Enclosed for your information and review are the responses to NRC comments on the Lakeview draft RAP. We will be available to discuss the responses more fully, as well as provide you a short design presentation, in September 1985.

Re: Response to NRC Comments on the
Lakeview Draft RAP, EA (D) PSCR,
(D) DSCR
Contract No. DE-AC04-82AL14086

RESPONSE TO
NRC COMMENTS DATED JUNE 19, 1985
ON
LAKEVIEW ENVIRONMENTAL ASSESSMENT
LAKEVIEW (D) REMEDIAL ACTION
LAKEVIEW (D) PSCR, AND
LAKEVIEW (D) DSCR (COLLINS RANCH SITE)

FIGURE 19.5. Curves showing the relationship between bearing-capacity factors and ϕ , as determined by theory, and rough empirical relationship between bearing capacity factors or ϕ and values of standard penetration resistance N .

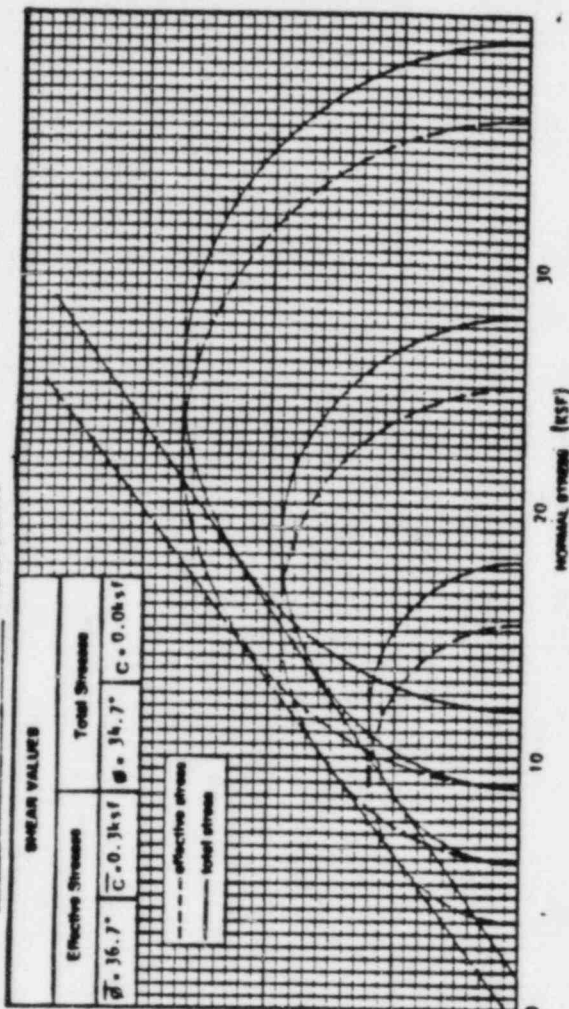
Page B-17. The method used for correlating blow count data with shear strength values should be specified. Friction angles of 38 degrees and 41.5 degrees for SM-ML materials appear somewhat high, based on typical values for a silty sand as shown on Table 17.1 of Terzaghi and Peck.

Blow counts were correlated to strength using Figure 19.5 from Peck Hansen and Thornburn (copy attached). The average blow count in the upper foundation soils was 36 and that of the lower foundation soils was 53. Laboratory tests were run on silt (MH) soils from these zones with resulting PHI angles of 38 degrees and 41.5 degrees. Subsequent laboratory testing resulted in effective PHI angles of 39.5 degrees for a silty sand with gravel and 36.7 degrees for a similar material obtained from the deeper layer. Based on the triaxial test data, it is considered that the strength parameters selected are realistic for the materials encountered, and that an effective PHI angle of 38 degrees is conservative and appropriate for both layers.
